Response to request for information for proposed modification to tyre recycling facility at 1-21 Grady Crescent, Erskine Park (MOD 23/0058).

RE: Tyrecycle Modification Noise Assessment – Request for Information

2869

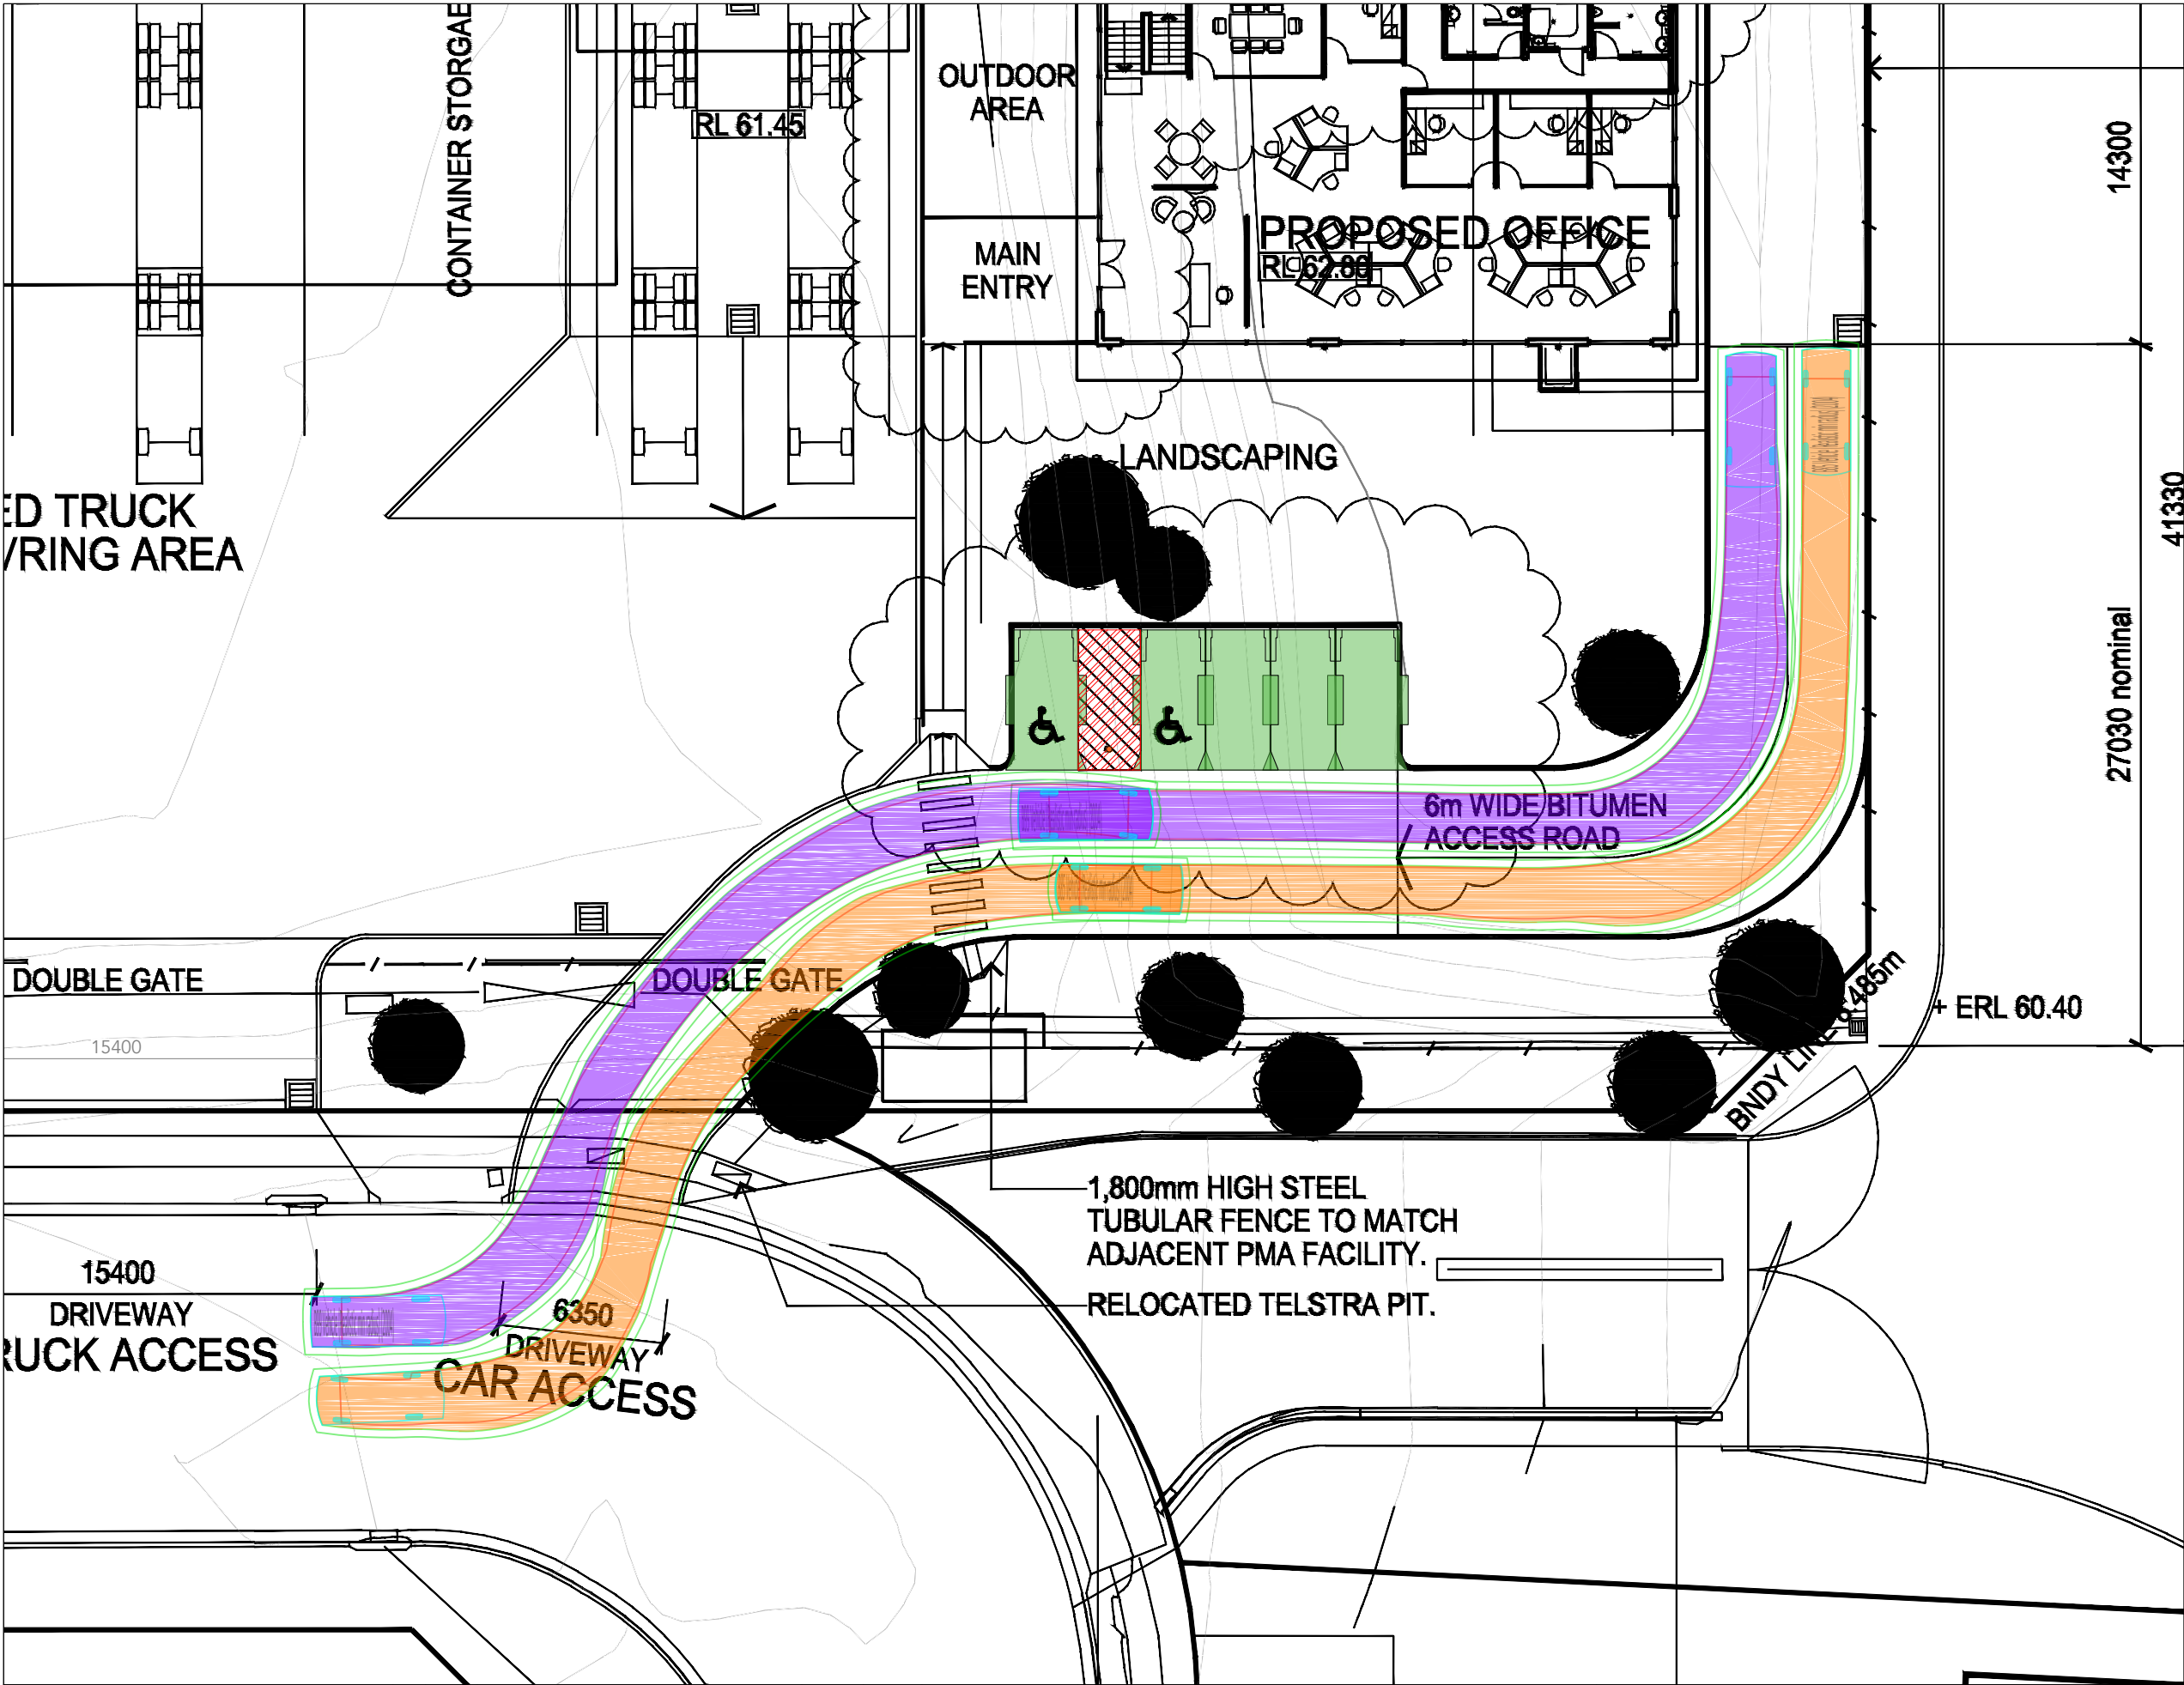
The pre-lodgement advice outlined: "The application shall be supported by turning swept paths in accordance with AS2890 clearly demonstrating satisfactory manoeuvring on-site (both internal and external) for light and heavy vehicles with forward entry and exit to and from the public road, noting the increased use of the loading docks on site."

This information has not been submitted and is therefore requested.

Letter correspondence was provided to Council on 14 November 2022 which clarified certain requirements noted in Council's pre-lodgement meeting minutes dated 15 September 2022. The letter noted that the proposed modification will not require new or additional truck configurations, nor will require an alteration to the approved site development plan or internal maneuverability pathways. As such, the existing and approved swept path diagrams for the development remain applicable and do not require amendment.

This is reiterated in Chapter 4 and Section 5.3.2 of the Statement of Environmental Effects submitted with the application.

The original swept path diagrams approved with the existing development consent are included as Attachment B for ease of reference.
